## Railpican P1A errata

Figure 1: Needed patches

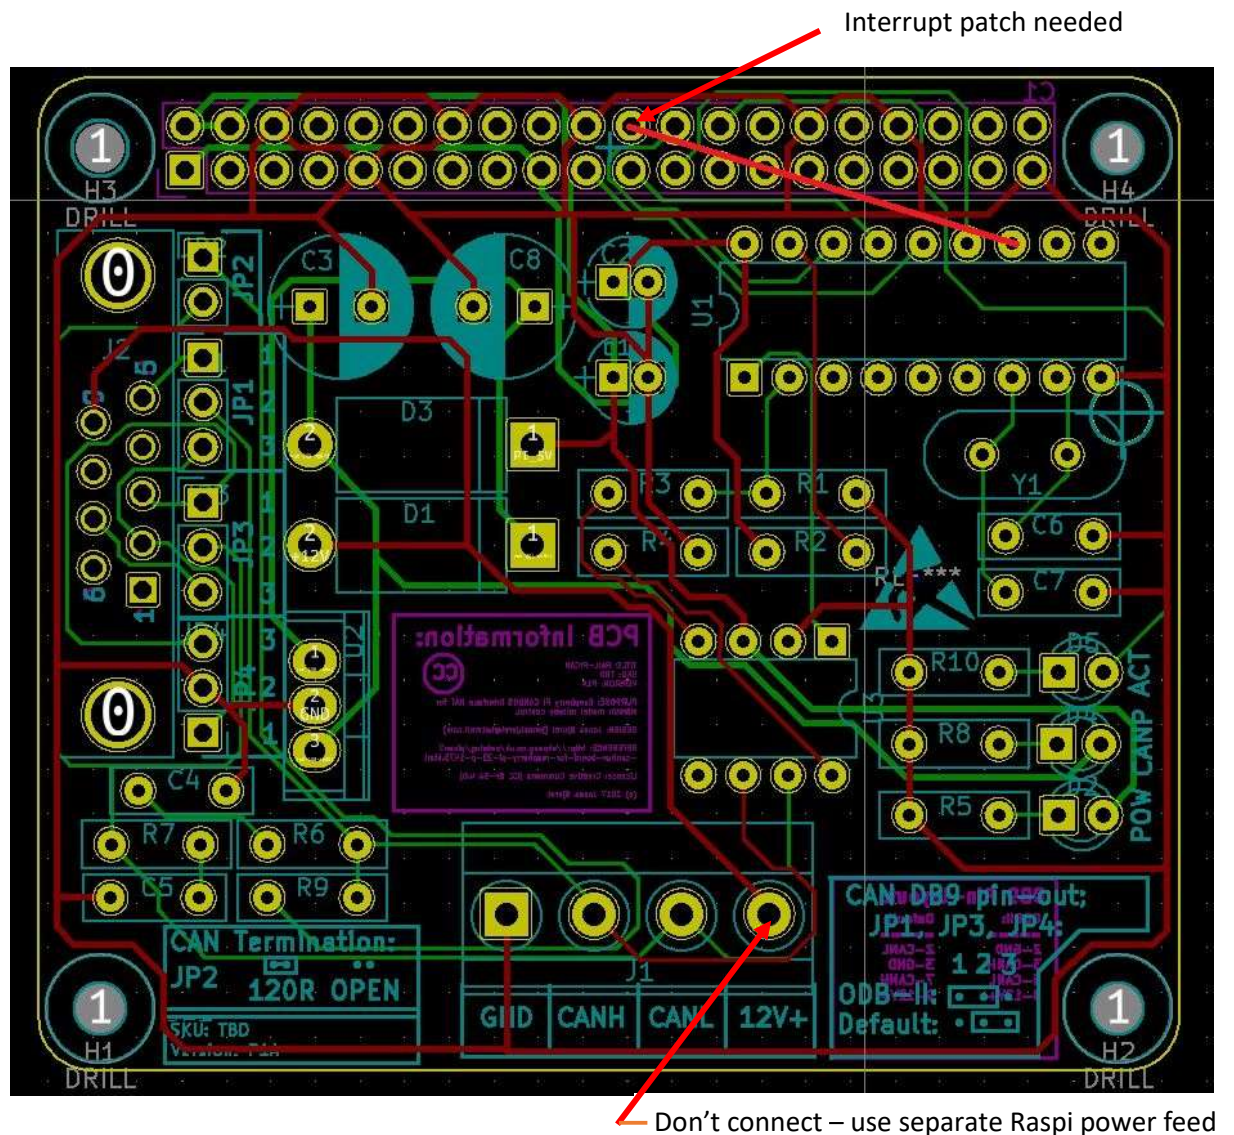
- 1) The CANBUS controller “u1 - MCP2515-I/P” interrupt is not connected to the raspberry pi interrupt pin. A patch-wire is required between pinhead connector pin 22 and u1 pin 12.
- 2) The voltage regulator to feed the Raspberry pi from the 12V CANBUS terminal screw connector is becoming way too hot. Don't connect the 12 V terminal, and feed the Raspberry pi separately from USB or similar.
